[Docket No. FAA-2025-0618; Project Identifier AD-2024-00637-T;

Amendment 39-23280; AD 2026-05-07]

Airworthiness Directives; The Boeing Company Airplanes

ACTION: Final rule.

Figure 1 to paragraph (h)(4) – Cap seal minimum thickness (all dimensions in inches)

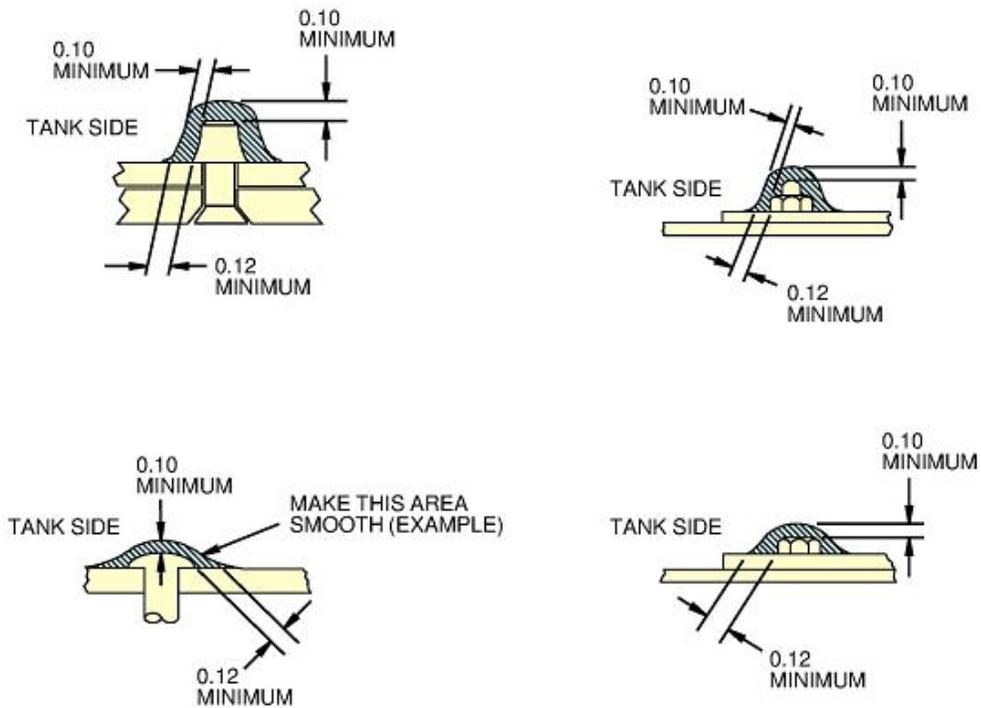
Boeing requested that the FAA remove paragraph (h)(3) and figure 1 from the proposed AD. Boeing stated Boeing Alert Requirements Bulletin 767-57A0148 RB, dated October 10, 2024, refers to section 28-11-00 of the 767 Aircraft Maintenance Manual (AMM) (i.e., 767 AMM 28-11-00) for the cap sealing procedure, and the AMM contains the same cap seal minimum thickness specified in figure 1 to paragraph (h)(3) of the proposed AD. Boeing asserted that deleting the proposed requirement would prevent duplication of data and potential questions from operators.

Alternatively, Boeing requested the FAA revise paragraph (h)(3) of the proposed AD to clarify that the requirement applies to in-tank fastener cap sealing only and add a note to refer to 767 AMM 28-11-00 as an acceptable cap sealing procedure for in-tank fasteners. Boeing stated this clarification would prevent potential questions from operators and eliminate conflicting cap sealing requirements for out-of-tank fasteners.

FedEx requested that the FAA remove figure 1 and revise paragraph (h)(3) of the proposed AD to require application of the cap seals to wing tank fasteners internally, in accordance with section 51-20-05 of the 767 Structural Repair Manual (SRM) (i.e., 767 SRM 51-20-05). FedEx stated the exception in paragraph (h)(3) of the proposed AD would result in multiple requirements for cap sealing of fasteners internal to the fuel tank, depending on the task being worked. FedEx also stated that the exception is overly general and should be specific only to cap seals internal to the fuel tank. FedEx noted fasteners that penetrate the 767 fuel tank are subject to Critical Design Configuration Control Limitations (CDCCLs) to ensure the lightning, fault current, and hot short protection requirements of Airworthiness Limitation (AWL) 28-AWL-08 are met. FedEx also noted that AWL 28-AWL-08 specifies no additional FAA Oversight Office approval is required if the repair or alternation is accomplished using 767 SRM procedures.

The FAA agrees that the cap sealing requirement of paragraph (h)(4) of this AD (corresponding to paragraph (h)(3) of the proposed AD) does not apply to fasteners outside the fuel tank. Accordingly, the FAA has revised paragraph (h)(4) of this AD to clarify the requirement applies only to fasteners, fastener heads, and fastener threads and collars inside the fuel tank.

The FAA disagrees with Boeing's request to remove the exception or add a note to refer to 767 AMM 28-11-00 as an acceptable procedure for the cap sealing required for in-tank fasteners. Boeing Alert Requirements Bulletin 767-57A0148 RB, dated October 10, 2024, already refers to 767 AMM 28-11-00 as an acceptable procedure, so including such a note in this AD is unnecessary. Further, referencing material as an accepted procedure does not make the actions in the material mandatory. Therefore, the FAA has determined that the exception in paragraph (h)(4) is necessary to ensure the cap sealing procedures are enforceable.

As stated previously, the FAA agrees that the cap sealing requirement does not apply to fasteners outside the fuel tank and has revised paragraph (h)(4) of this AD accordingly. However, the FAA disagrees with the commenter's request to require that the cap sealing for in-tank fasteners be done in accordance with 767 SRM 51-20-05 because the SRM refers to 767 AMM 28-11-00 for sealing of fuel tank repairs. Referring to 767 AMM 28-11-00 does not make the actions in that material mandatory, and the FAA has determined that the requirements in paragraph (h)(4) of this AD must be accomplished. Further, the FAA disagrees that the exception will result in multiple requirements for cap sealing of fasteners internal to the fuel tank because the 767 AMM 28-11-00 contains the same procedures as the requirements of figure 1 to paragraph (h)(4) of this AD. The FAA has not changed the AD in this regard.

(4) During application of any cap seal to a fastener, fastener head, and fastener threads and collars inside the tank, as required by this AD, the cap seal must be applied with a thickness equal to or greater than the dimensions specified in figure 1 to paragraph (h)(4) of this AD.
